PROJECT TITLE		KENSAL CORRIDOR	
BDP JOB NUMBER	BDP OTHER CLASSIFICATION	SCALE	DATE
P2007403		1:100 @ A1	19/07/2019
DRAWING TITLE		DATE	REVISION
GENERAL ARRANGEMENT		19/07/2019	7
SHEET 8			
DRAWING NO.			
P2007403-BDP-XX-XX-DR-C-1008

REVISION 7 UPDATES:
PARKING EXTENDED FROM
12M LENGTH TO 14M
LENGTH.
TREE 21 AND KERB 50
REALIGNED
ACCORDINGLY.

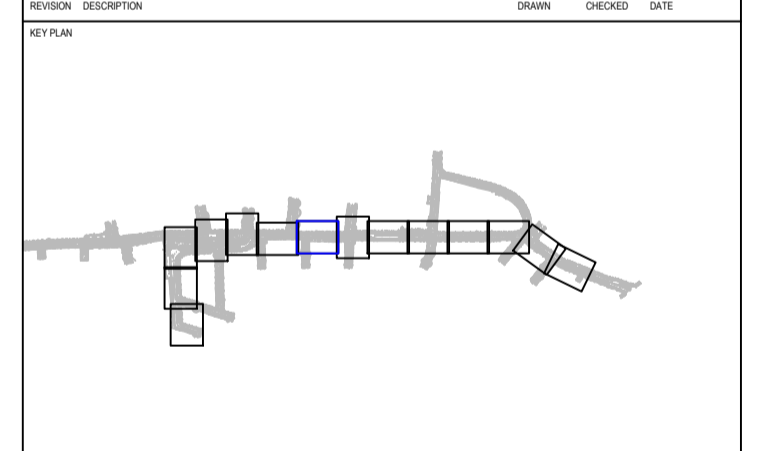
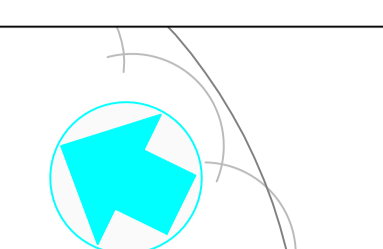
REVISION 7 UPDATES:
LOADING BAY EXTENDED
FROM 12M LENGTH TO 14M
LENGTH.
TREE 23 AND KERB 50
REALIGNED
ACCORDINGLY.
